APPARELWERKS

Pattern DXF file inspection and ANSI/AAMA-292 compliance evaluation

TBD9-Denim Pants.dxf

Analyzed 06 October 2026

Evidence — 左后片-34*32-11

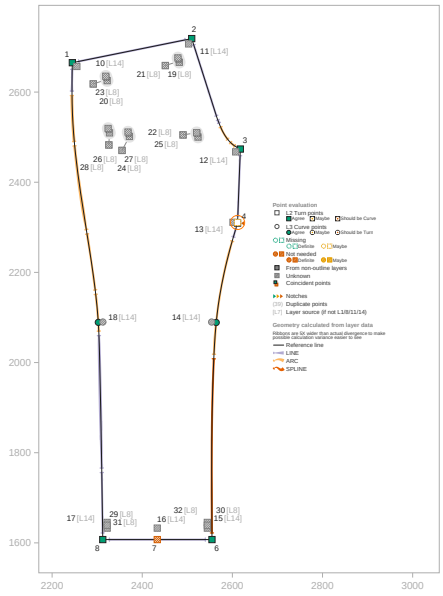
Corners missing from layer 2

Block 左后片-34*32-11: layer 2 is missing 1 of 6 boundary corners (a notable point not declared a turn point on layer 2) — ANSI/AAMA-292 §4.2.2 incompleteness. 4 other pieces are also missing corners.

AAMA-292 §4.2.2 (revised in ASTM D6673 §4.3)

左后片-34*32-14

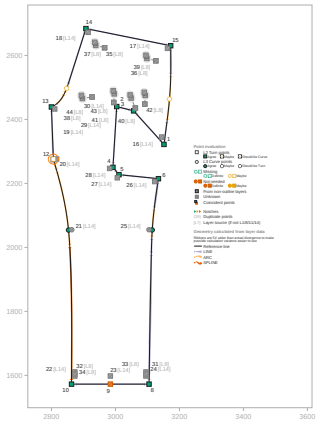
1 of 12 corners missing

左侧贴袋-34*32

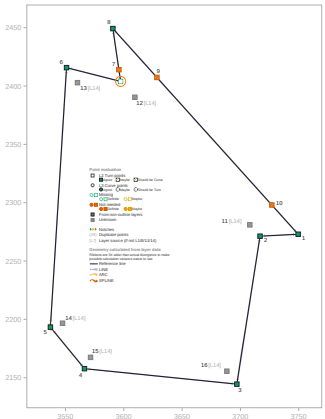
1 of 8 corners missing

裆底布里-34*32

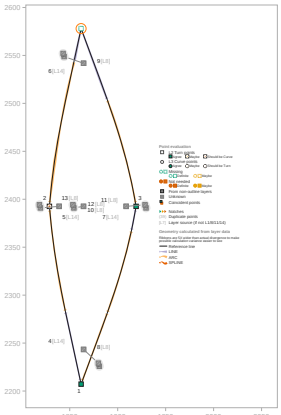
1 of 2 corners missing

后片里-34*32

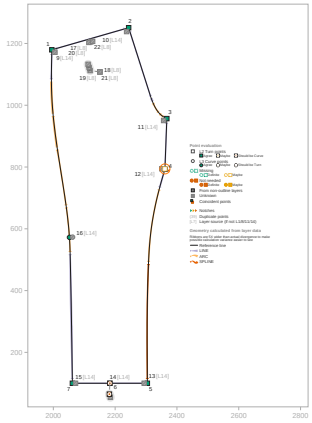
1 of 6 corners missing

左后片-34*32-14

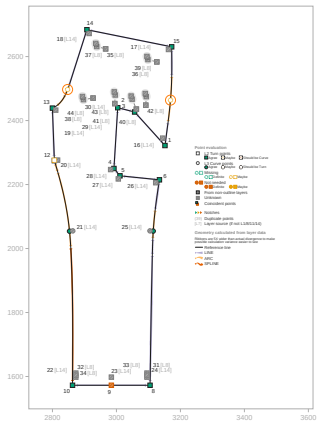
2 of 4 curve regions missing

Evidence — 腰面-34*32

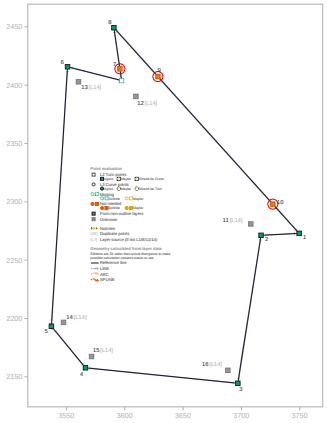
Block 腰面-34*32: 8 of 12 declared boundary points are miscategorized (ANSI/AAMA-292 §4.2.2-4.2.3) — 8 points on a straight segment. 13 other pieces also have miscategorized points.

左侧贴袋-34*32

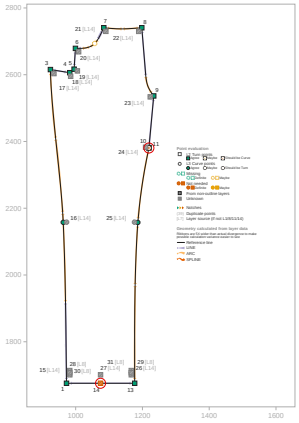
3 points miscategorized

右前片-34*32

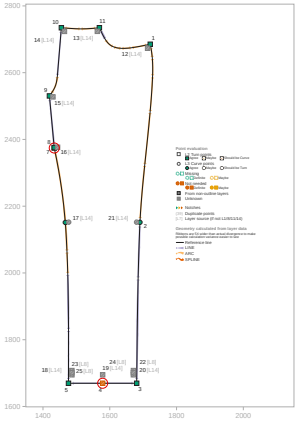
2 points miscategorized

左前片-34*32

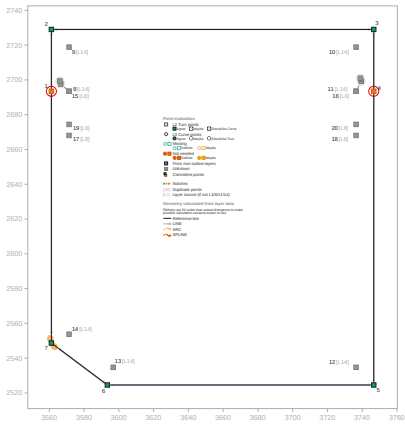
2 points miscategorized

后代里-34*32

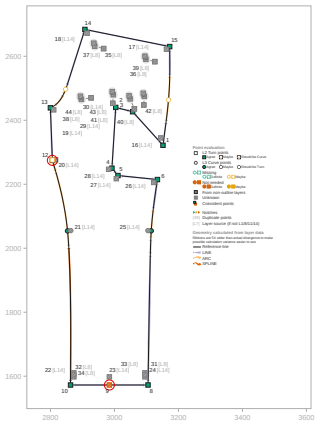
2 points miscategorized

左后片-34*32-14

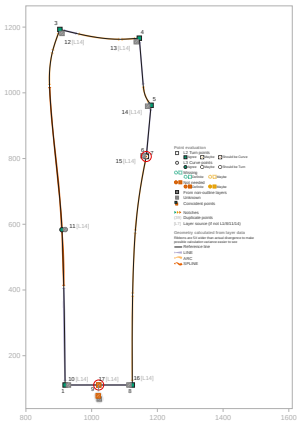
2 points miscategorized

右前里-34*32

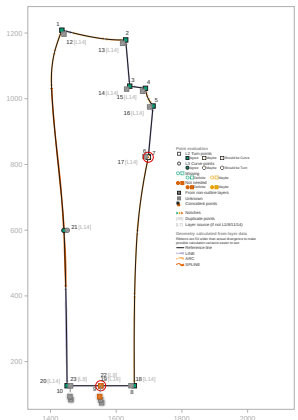
2 points miscategorized

左前里-34*32

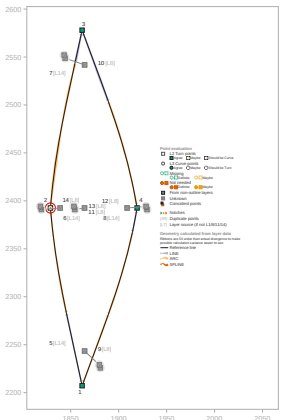
2 points miscategorized

裆底布-34*32

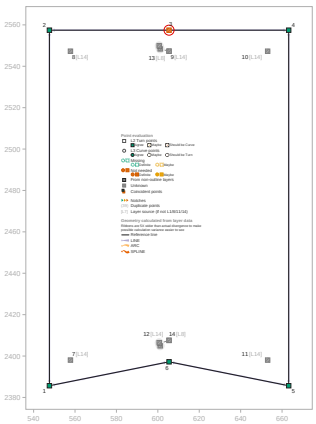
1 point miscategorized

里禁-34*32

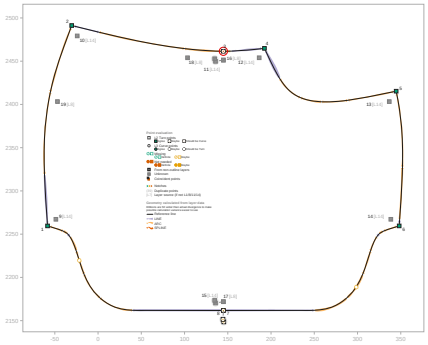
1 point miscategorized

前代步-34*32

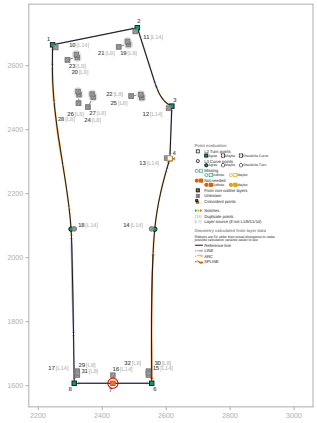
1 point miscategorized

左后片-34*32-11

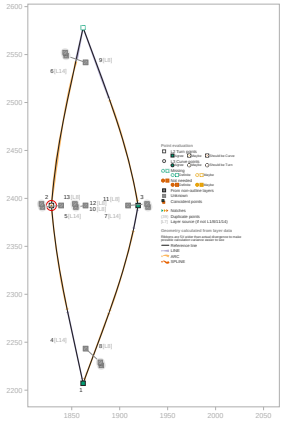
1 point miscategorized

裆底布里-34*32

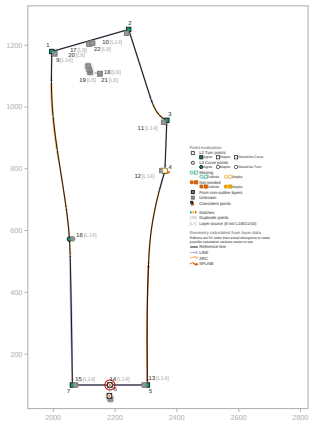
1 point miscategorized

Evidence — 腰面-34*32

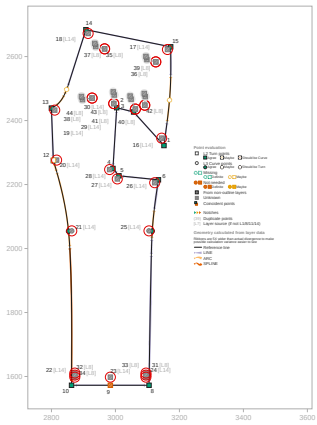
Block 腰面-34*32: 32 declared layer-2/3 points do not lie on the boundary line — ANSI/AAMA-292 defines layer 2/3 points as the Boundary Line Layer's points. These points lie on the internal line (layer 8) or the sew line (layer 14). 21 other pieces have similar points.

左后片-34*32-14

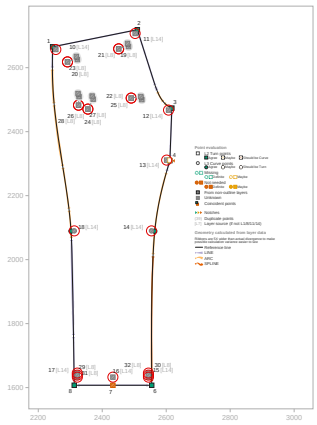
29 points that should not be on L2/L3

左后片-34*32-11

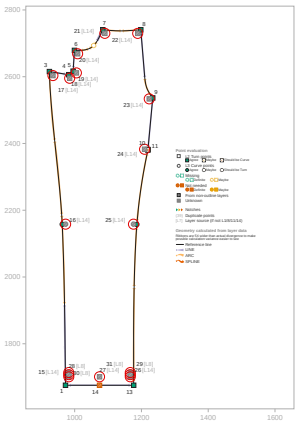
23 points that should not be on L2/L3

右前片-34*32

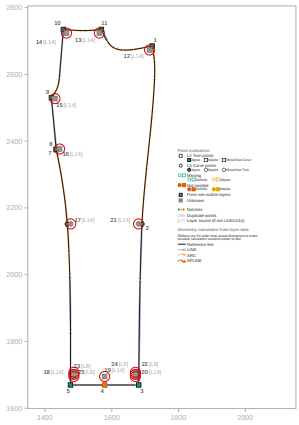
17 points that should not be on L2/L3

左前片-34*32

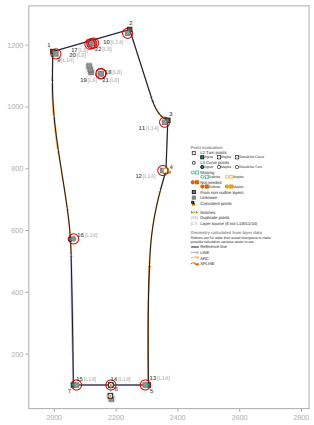
14 points that should not be on L2/L3

后片里-34*32

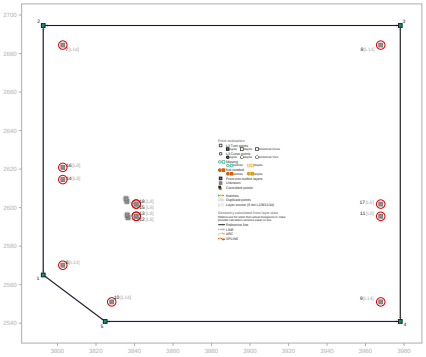
14 points that should not be on L2/L3

后代-34*32

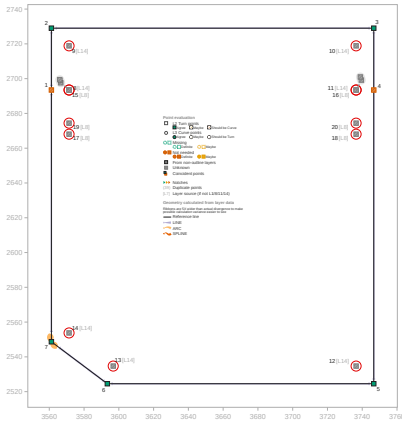
13 points that should not be on L2/L3

后代里-34*32

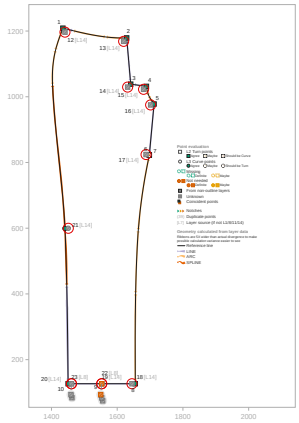
13 points that should not be on L2/L3

左前里-34*32

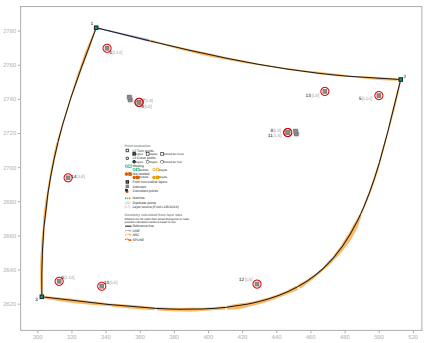
12 points that should not be on L2/L3

前代垫-34*32

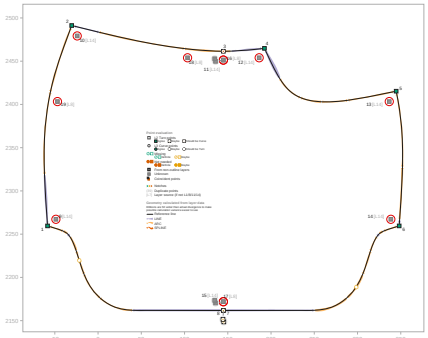
11 points that should not be on L2/L3

前代步-34*32

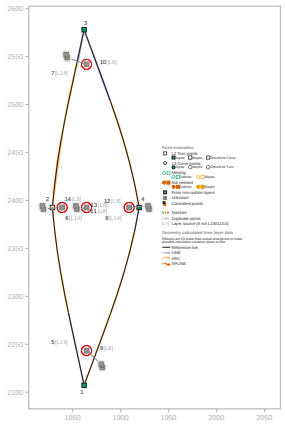
11 points that should not be on L2/L3

后约克-34*32

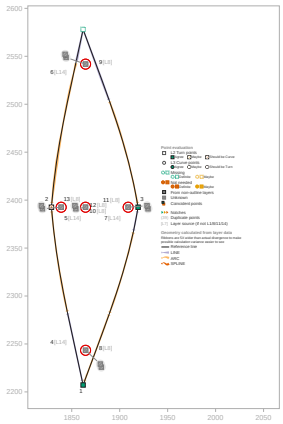
10 points that should not be on L2/L3

裆底布里-34*32

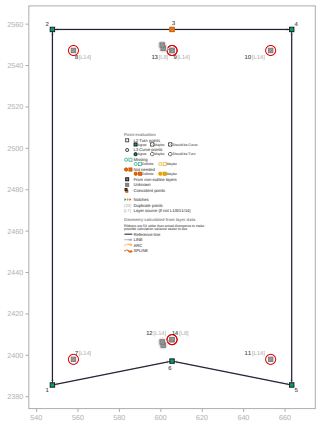
10 points that should not be on L2/L3

里禁-34*32

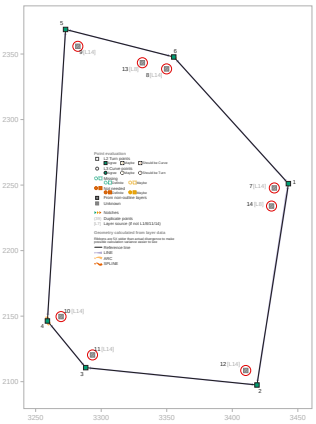
8 points that should not be on L2/L3

左侧拼块-34*32

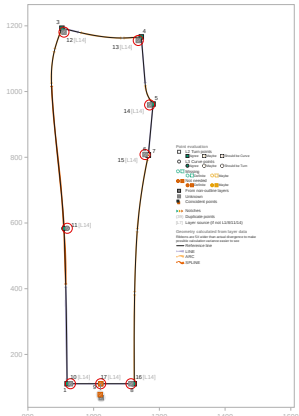
8 points that should not be on L2/L3

右前里-34*32

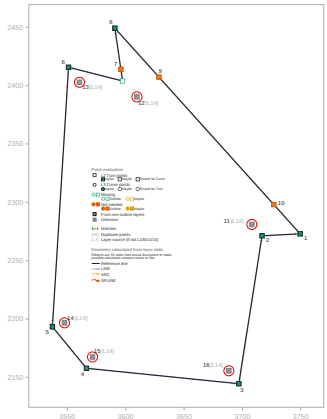
8 points that should not be on L2/L3

左侧贴袋-34*32

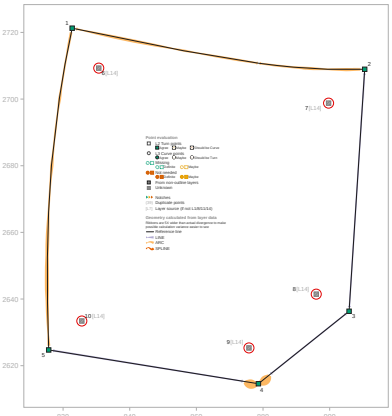
6 points that should not be on L2/L3

右前拼块-34*32-1

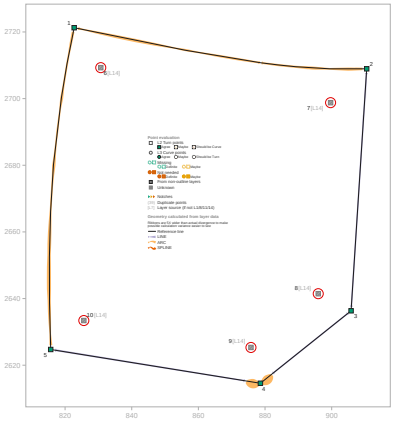
5 points that should not be on L2/L3

门禁-34*32

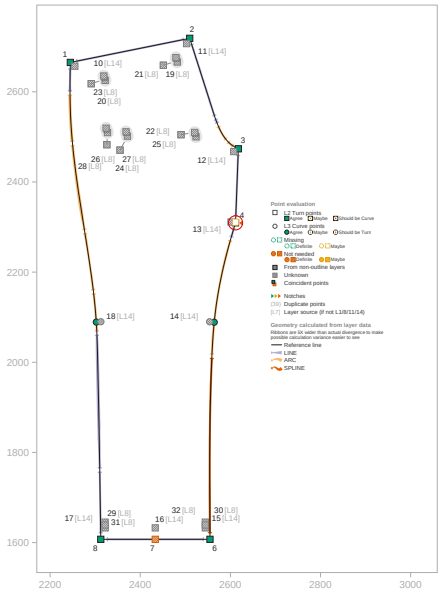
4 points that should not be on L2/L3

Evidence — 左后片-34*32-11

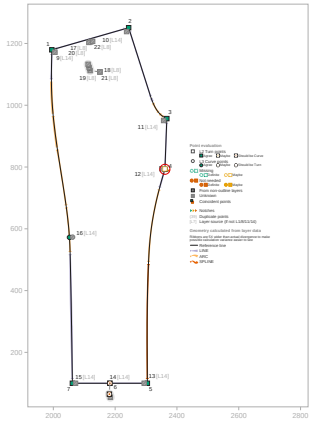
Block 左后片-34*32-11: 1 declared layer-2/3 point is there only as a notch base — no turn or curve justifies the declared type. 1 other piece has similar points.

Evidence — 门禁-34*32

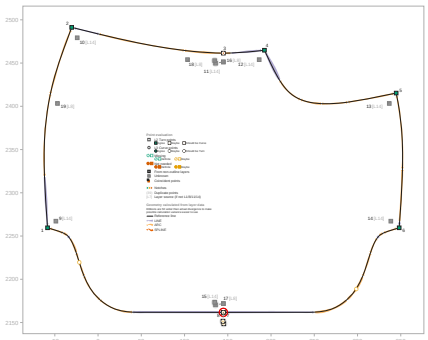
Block 门禁-34*32: 2 declared boundary points may be miscategorized. 1 other piece may also have miscategorized points.
